**STATE OF TENNESSEE
DEPARTMENT OF TRANSPORTATION**

INSTRUCTIONAL BULLETIN NO. 17-09

Regarding Revised Standard Drawings

Effective February 9th, 2018 letting (November 29th, 2017 Turn-in), the following Standard Drawings have been revised. Also, Section 5, Index of Standard Drawings, of the Roadway Design Guidelines has been revised to incorporate these changes.

S-GRT-1

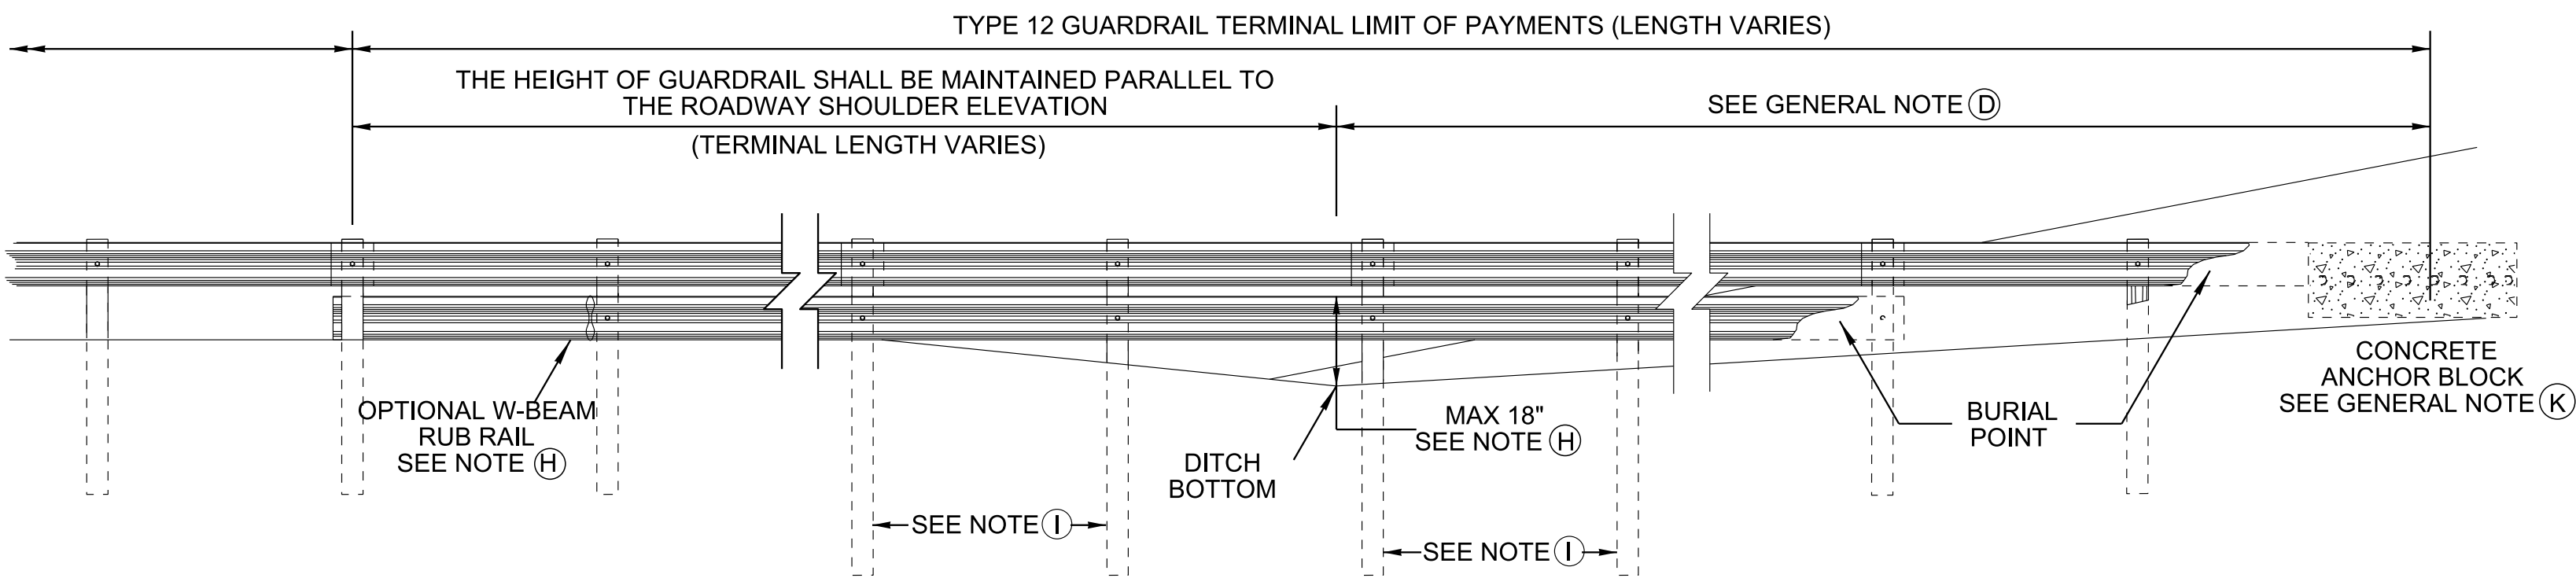
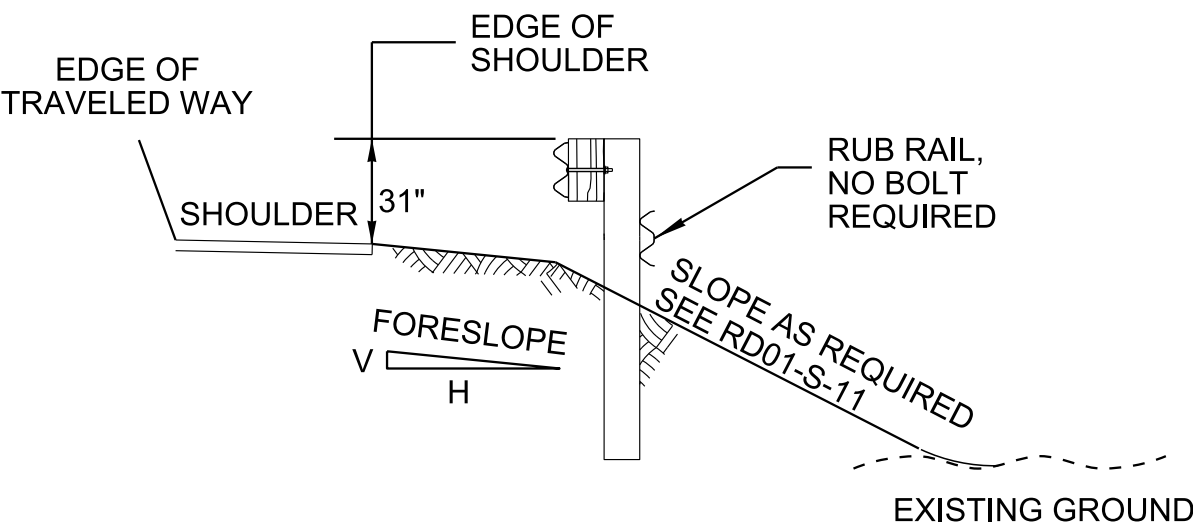
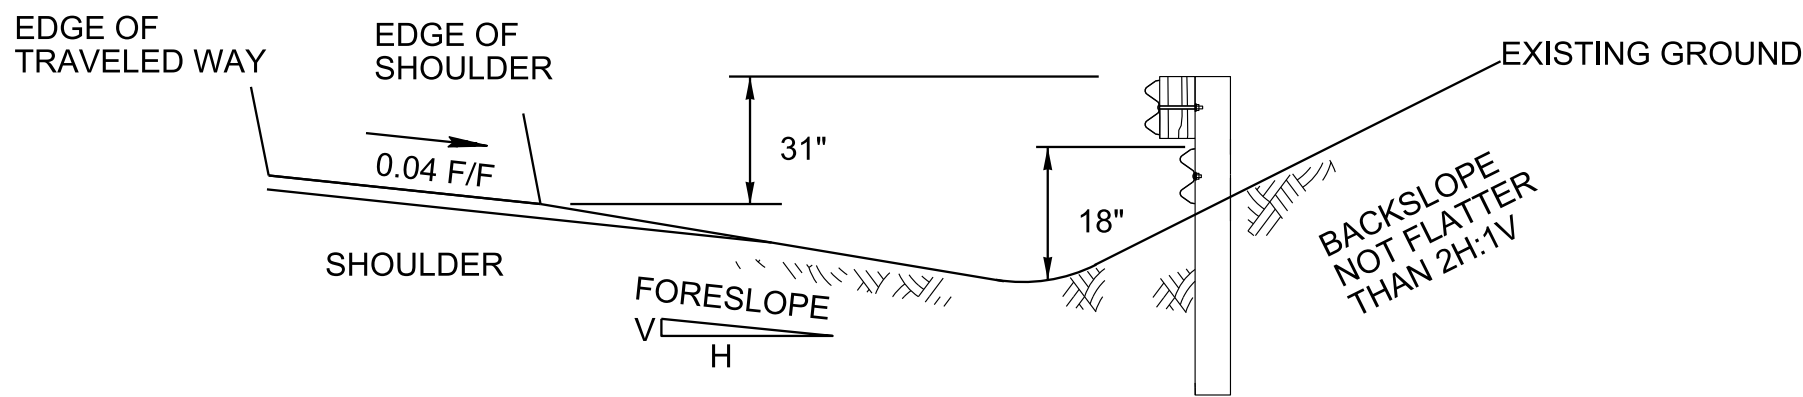
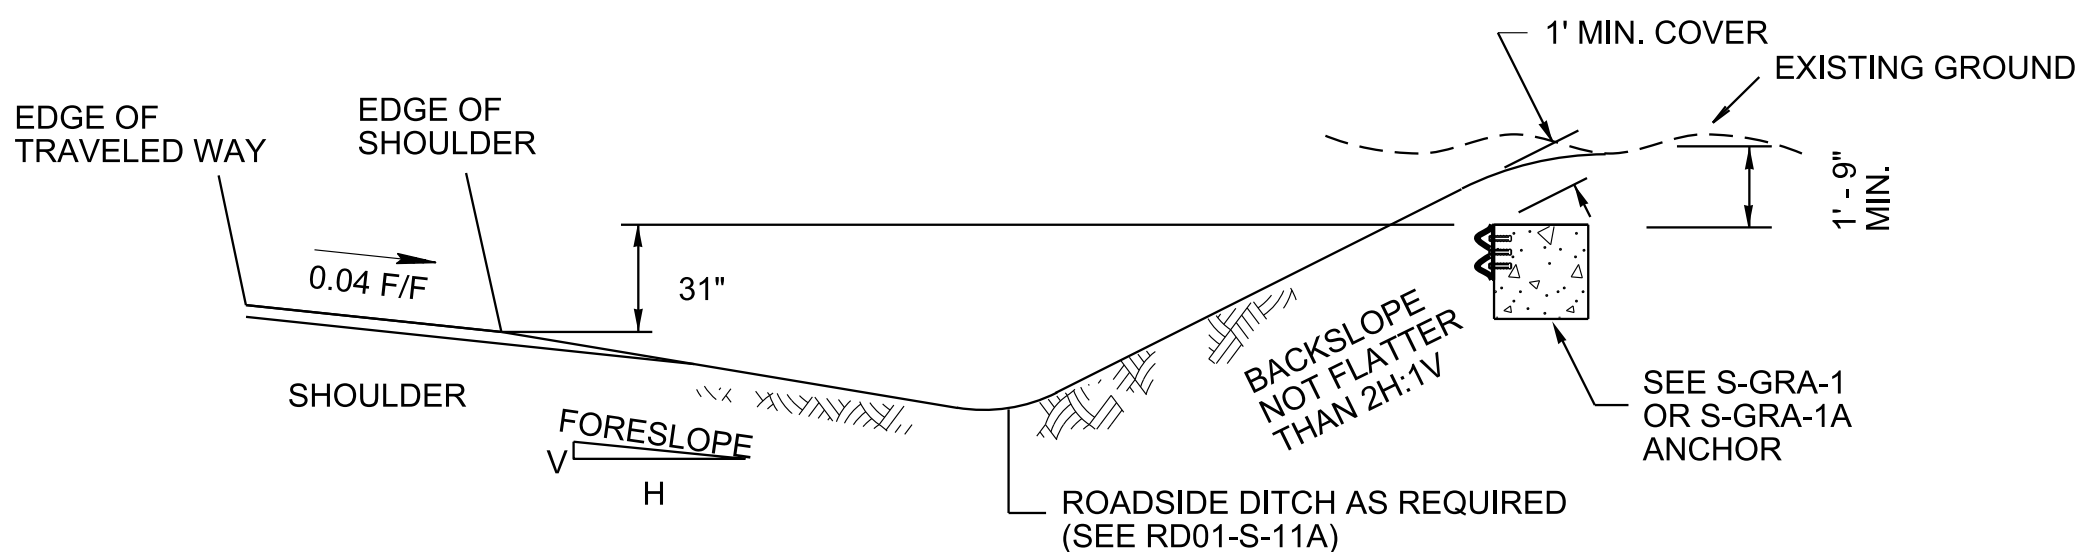
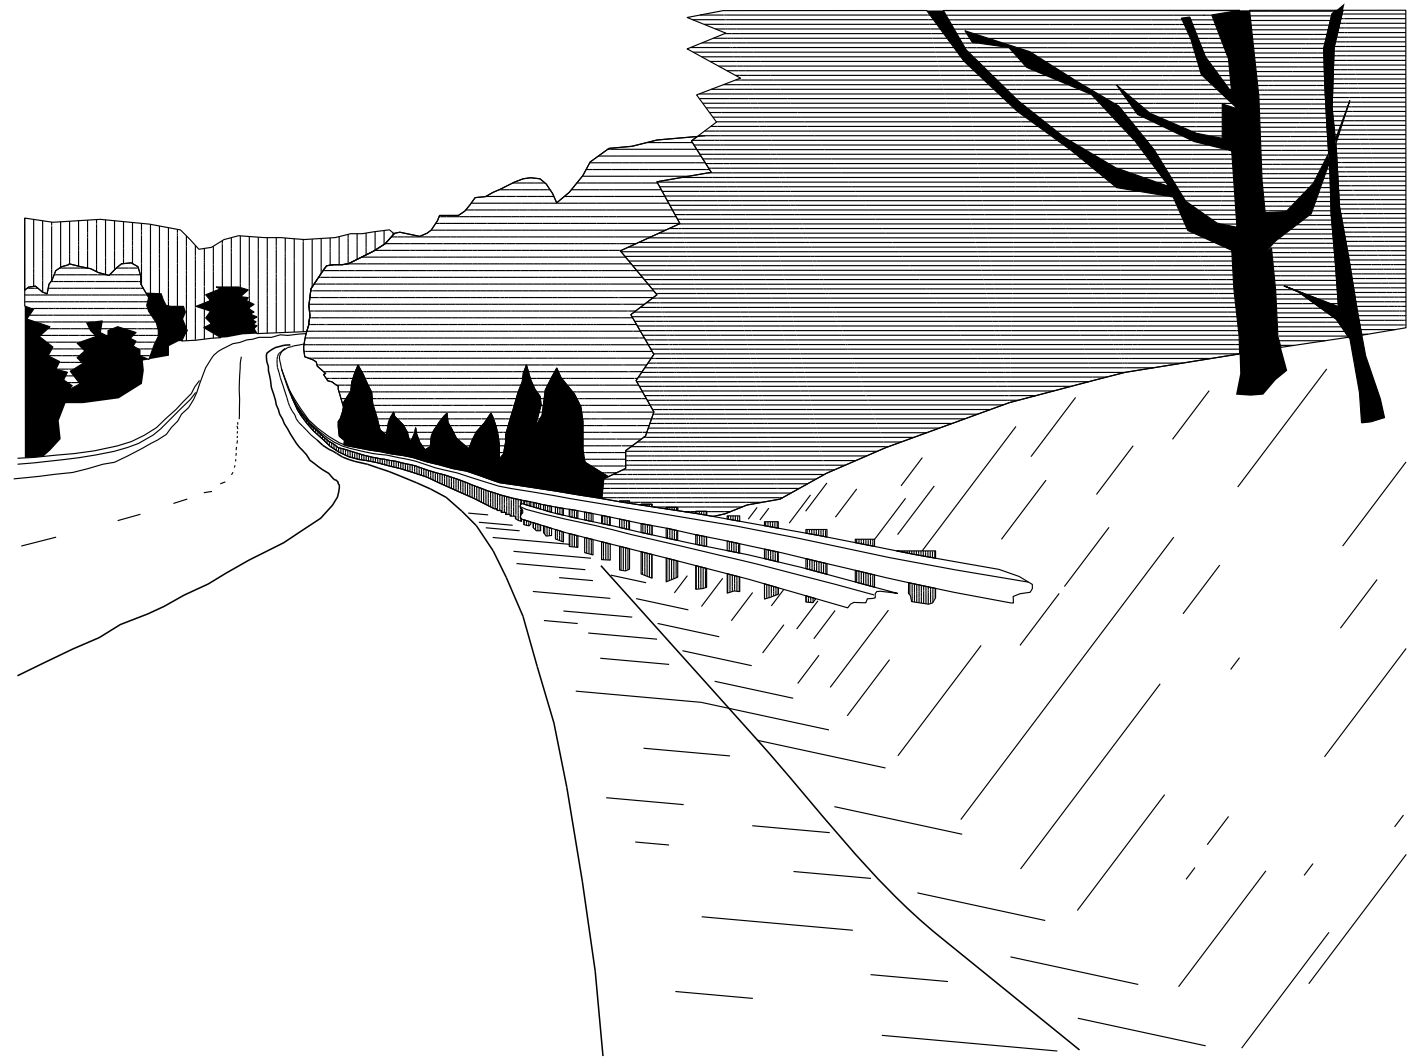
REV. 3-16-17: UPDATED
REFERENCE TO STD. DWG.
FROM "S-GRP-1" TO
"S-PL-1". CORRECTED
REF. TO STD. DWG. FROM
"RD-S-11" TO "RD01-S-11"
AND "RD-S-11A" TO
"RD01-S-11A".

DELINEATOR MOUNTED ON INTERCONNECTED TEMPORARY
PORTABLE CONCRETE BARRIER RAIL

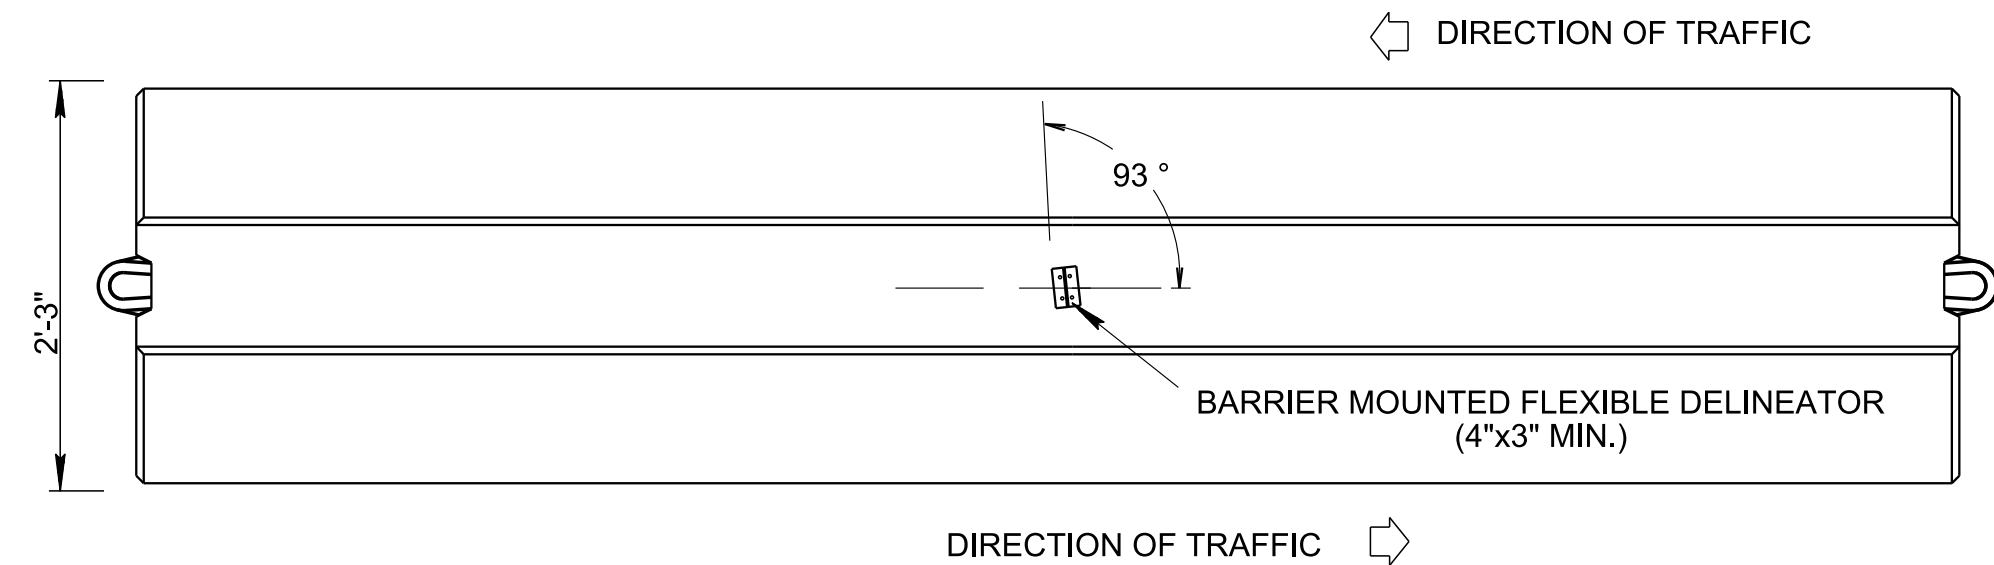
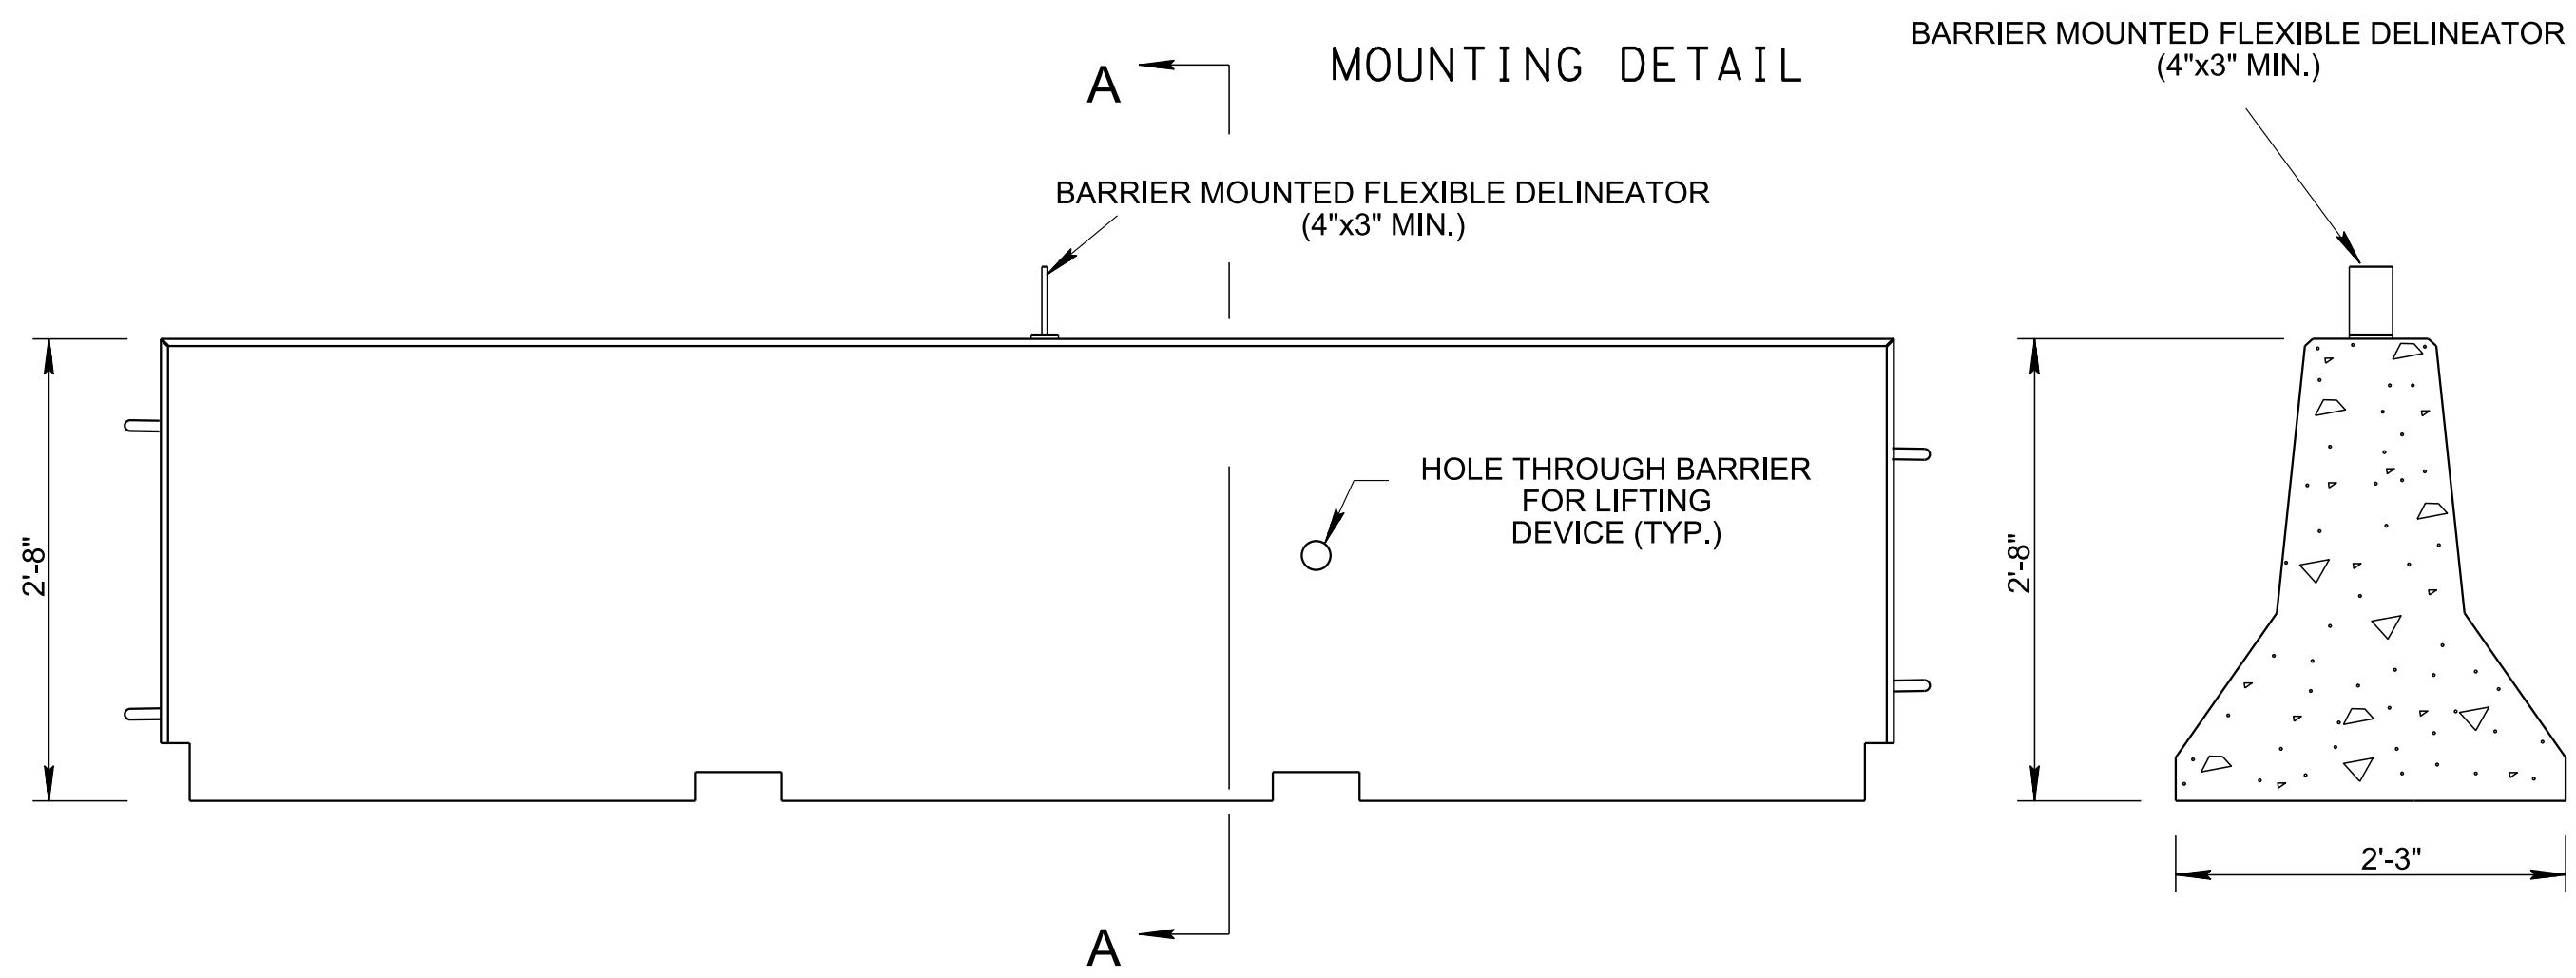
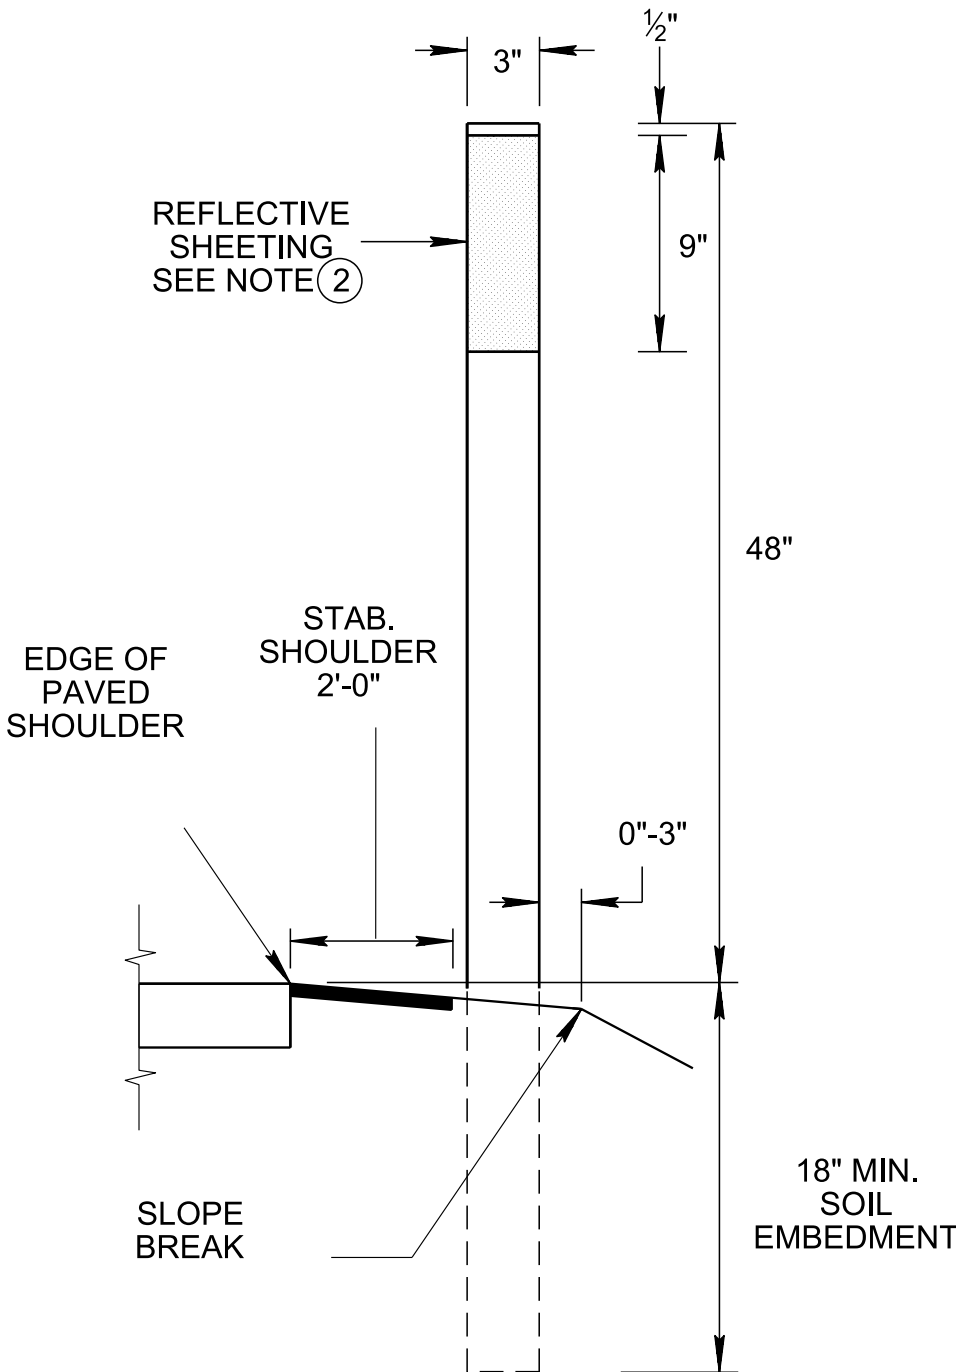
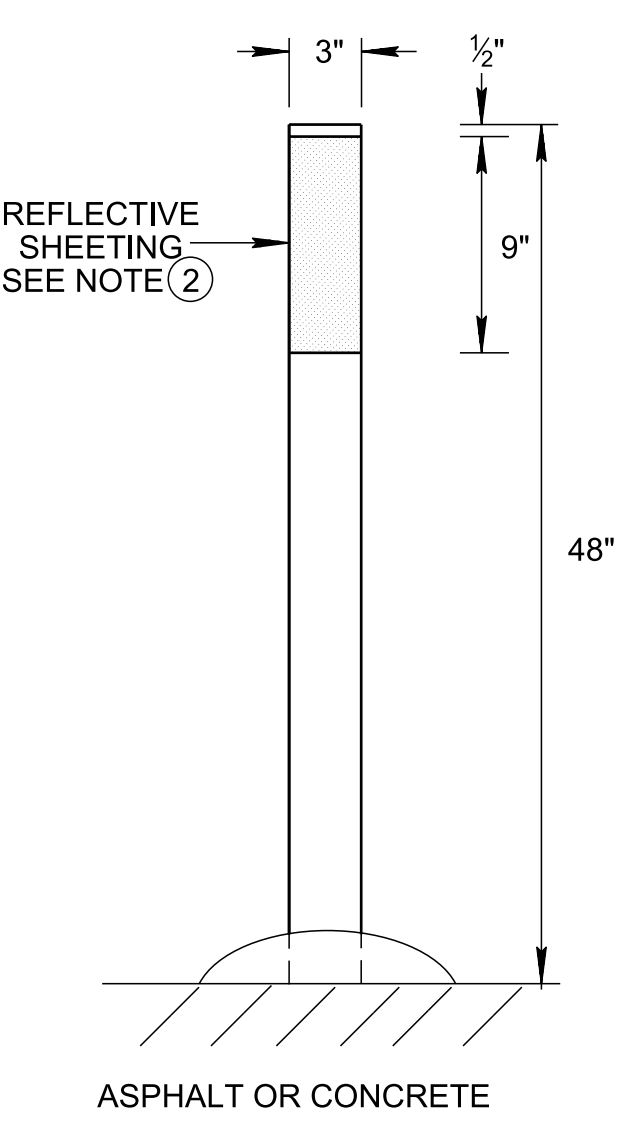
REV. 10-10-06: ADDED DETAIL FOR GROUND MOUNTED FLEXIBLE DELINEATOR AND GENERAL NOTES.
REV. 11-1-11: REVISED SHOULDER DETAILS.
REV. 3-16-17: ADDED DETAIL FOR SURFACE MOUNTED FLEXIBLE DELINEATOR. ADDED GENERAL NOTES. MODIFIED THE NAME OF THE DRAWING. CHANGED THE PAY ITEM NUMBERS. REPLACED VERTICAL PANELS WITH BARRIER MOUNTED FLEXIBLE DELINEATORS.
